SERVICE INFORMATION NO. SI D4-046

GTX 327 or GTX 32 Software upgrade
ATA-Code: 34-00

SOFTWARE SERVICE BULLETIN

SUBJECT: GTX 327, GTX 32 Software Upgrade to Version 2.09 for non-G1000 applications only

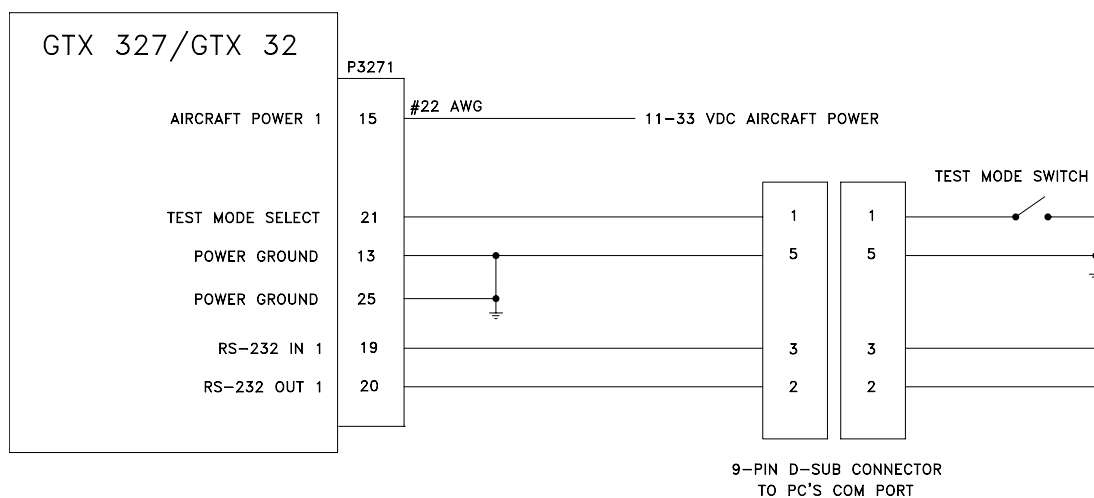
1. Assemble a test harness for the GTX 327/32 as shown in the following figure:

2. Ensure that the unit is turned off. Connect the GTX 327/32 to the test harness and apply power to the harness.
3. With the unit off, enable test mode via the Test Mode Switch. (Applies a ground to P3271 pin 21).
